**RE: Curia Building Addition
34401 Alexander Blvd. NE Albuquerque, NM 87107
Grading and Drainage Plan (F16D003B1)
Engineers Stamp Date 10/25/2022**

Re: Curia Building Addition
4401 Alexander Blvd NE Albuquerque, NM 87107
Grading and Drainage Plan (F16D003B1)
Letter of Response

RE: **Oso Bio Syringe Line**
4401 Alexander Blvd NE
Grading and Drainage Plan for Building Permit
Engineer's Stamp Date 11/1/2018 Disapproved
Hydrology File: F16D003B1

Re: Oso Bio Syringe Line Grading Plan Submittal; Hydrology File F16D003B1

OSO BIO SYRINGE LINE GRADING PLAN			
DRAWN BY:	DATE:		
CHECKED BY:	PROJECT NO. 20190058	SHEET NO.	C1.4

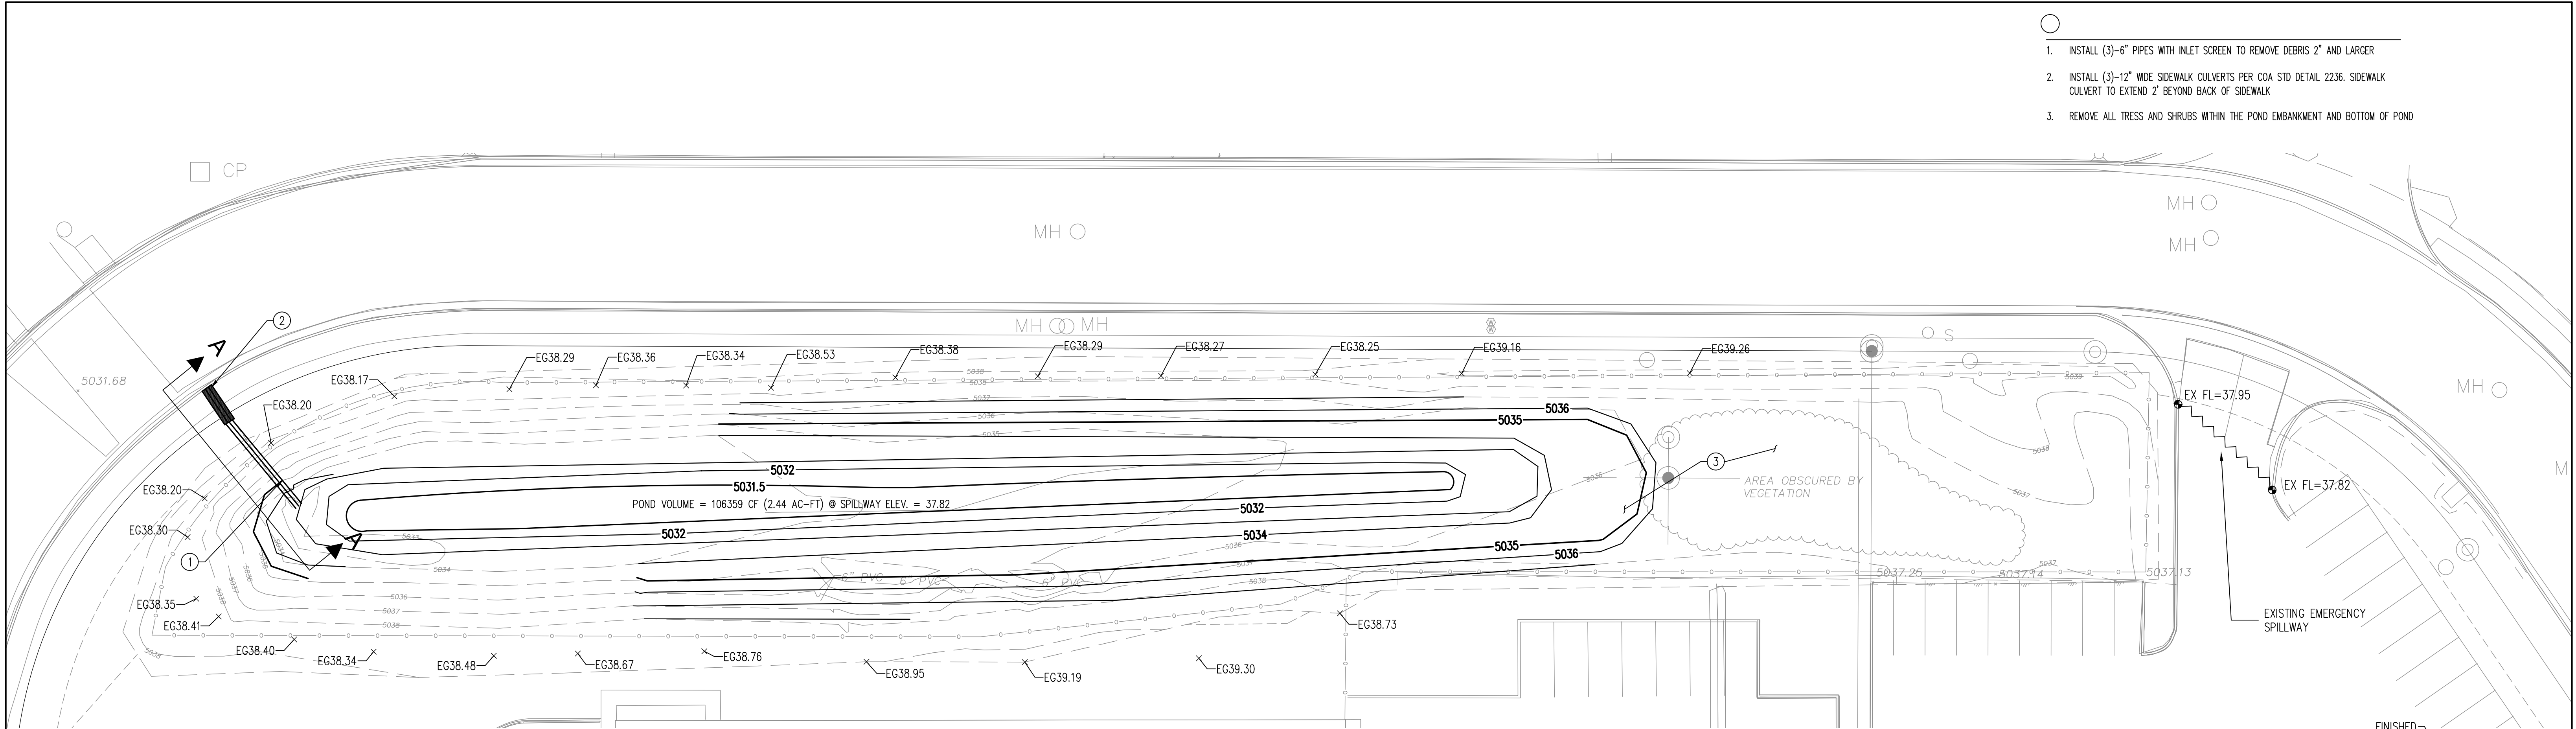
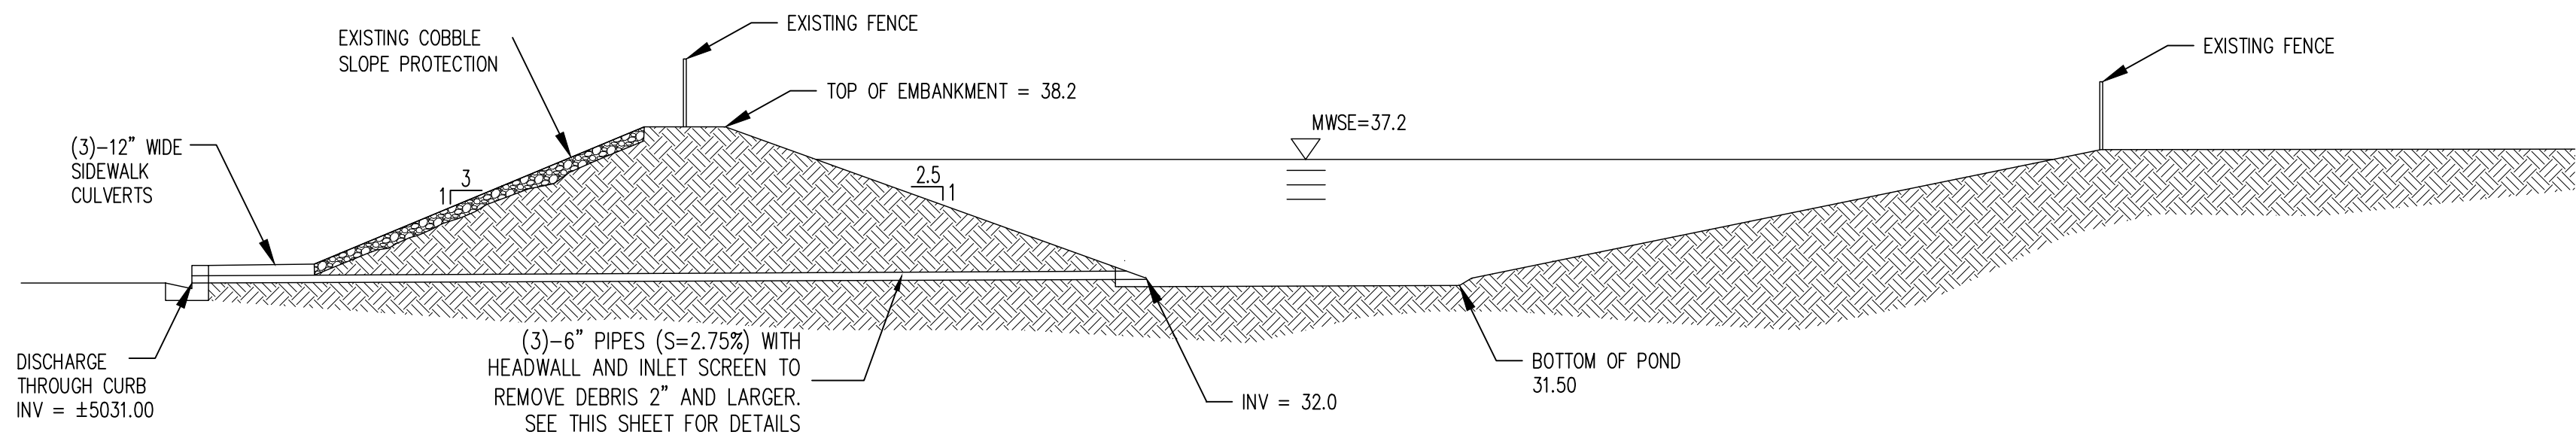
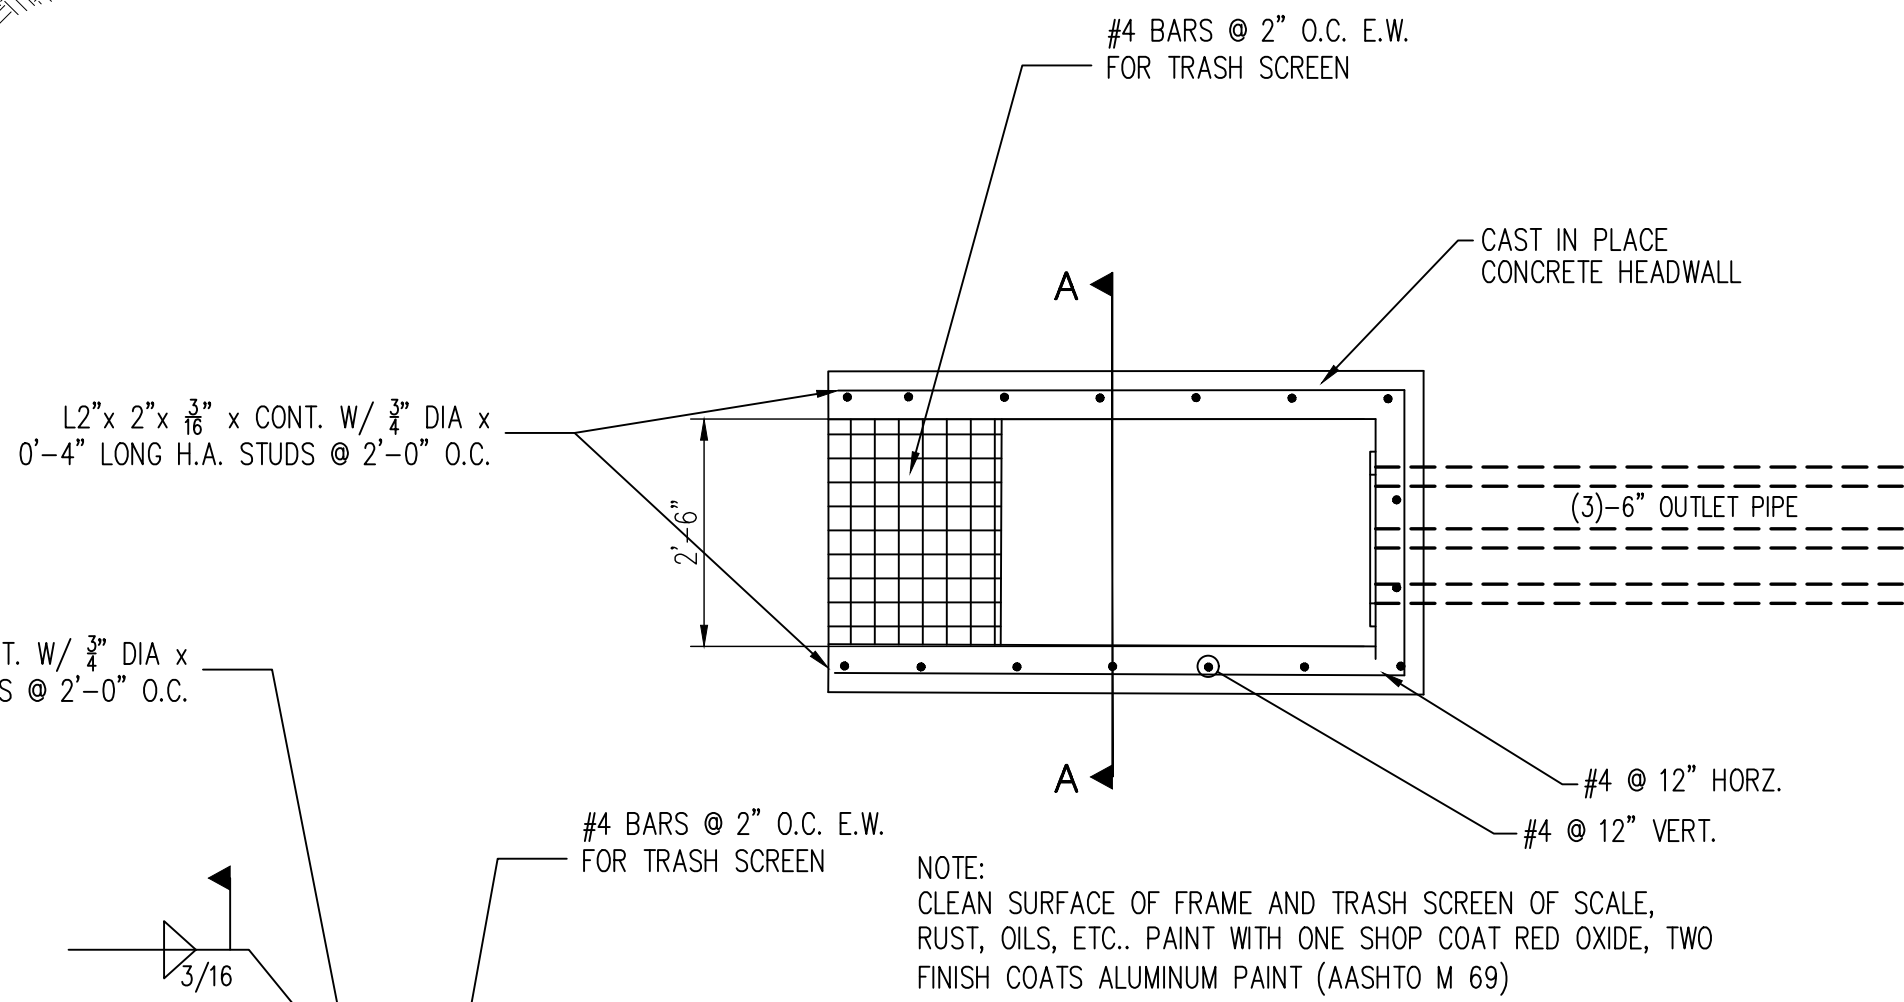
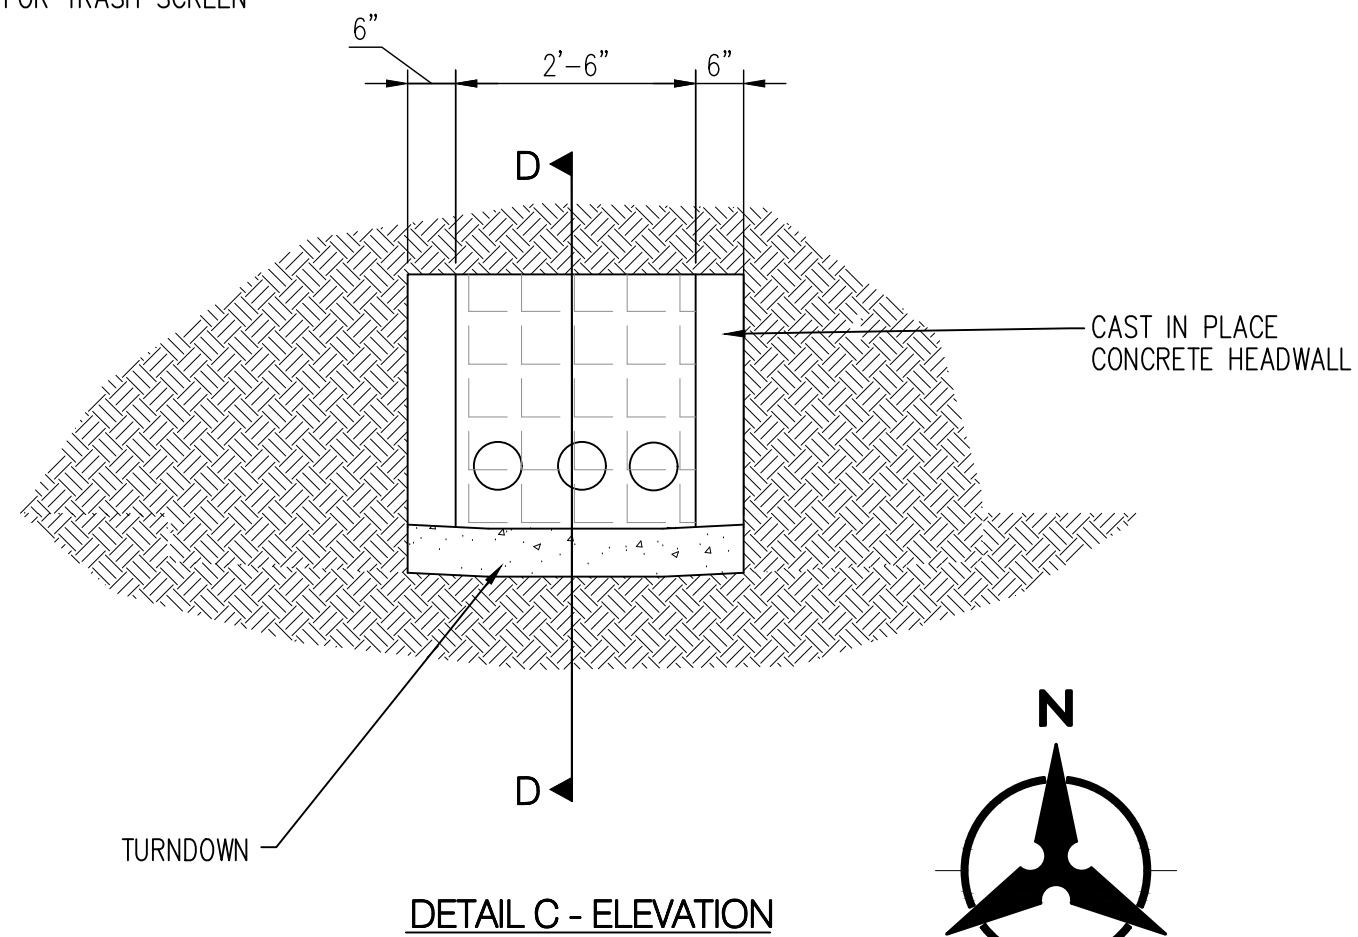
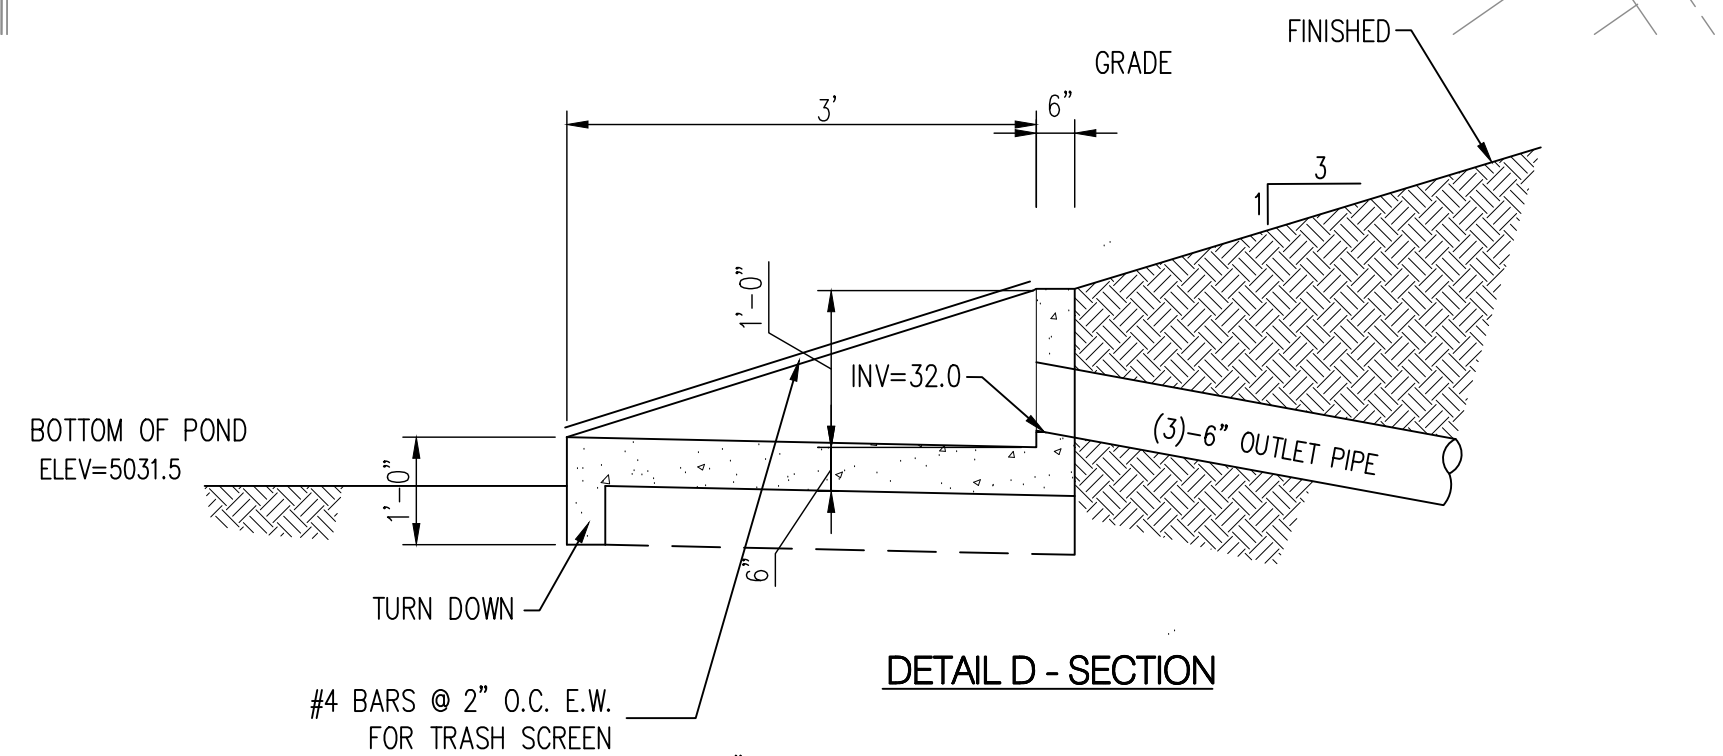
1. In the HEC-HMS Model:
 - a. Per the draft DPM, 6-1(B)(2) *Computation of Time of Computation*, if t_c is computed to be less than 0.2hrs, than use 0.2hrs. Lag time then becomes $0.6 * t_c = 7.2$ minutes.
 - b. The inlet elevation for the PVC pipes is specified as 5033' but is 5032' in the plans.
 - c. The outlet elevation for the PVC pipes is specified at 5031.9' but is ~5031' in the plans; also the outlet elevation of the pipes and the Invert-In and Invert-Out of the sidewalk culverts should be specified on the plans.
 - d. The bottom of pond is defined as 5031' in the model, but shown as 5031.5' on the plans.
2. The proposed 100-yr WSEL needs to be shown on the pond in plan view.

4. Spot elevations from the survey have been added to the top of berm and spillway. The is shown on sheet C1.4. Transportation has agreed to allow the two northern driveways on the site to remain open if the owner will remove the concrete barriers. The owner has agreed to this. Spillway calculations are shown on the proposed DMP.

5. The MWSE has been added to the sections on both the plans and DMP. Keyed note 3 on sheet C1.4 notes to remove vegetation from the pond and embankment.
